October 8, 2020

Product Change Notice - Shorter screws, adjusted location for entry door strike plates

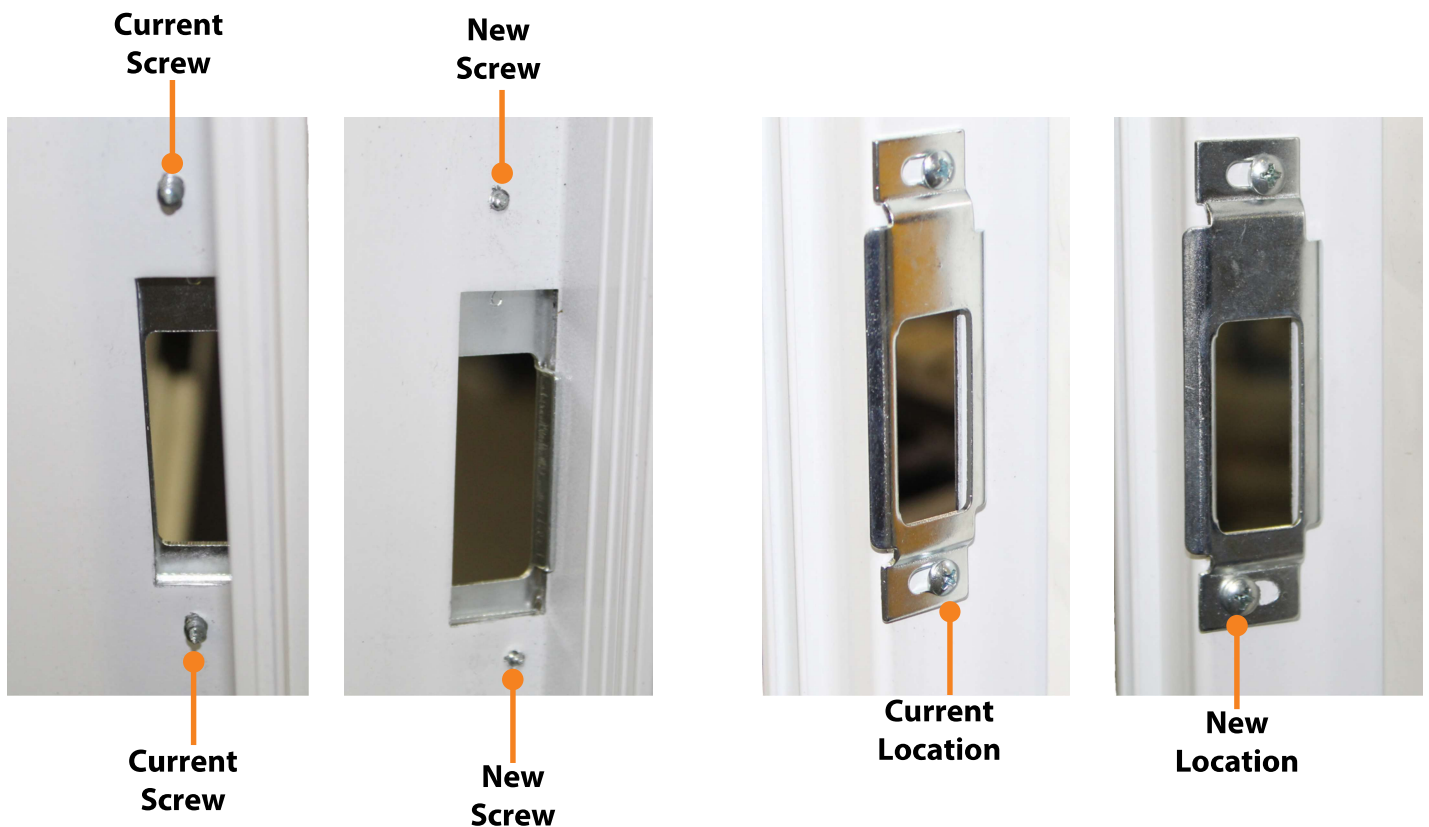
LCI intends to change the screw length for the strike plate on entry doors and the location of one of the screws in the strike plate.

It was determined using a shorter screw (Fig. 2) for the strike plate would make installing the door within approved tolerances easier for the OEM due to less of the screw protruding from the door.

Moving the bottom screw forward also adds to the plate's durability, ensuring the plate will not shift when the door is closed.

The part number for the current screw is 235110. The part number for the new screw is 206569. The change is taking place immediately.
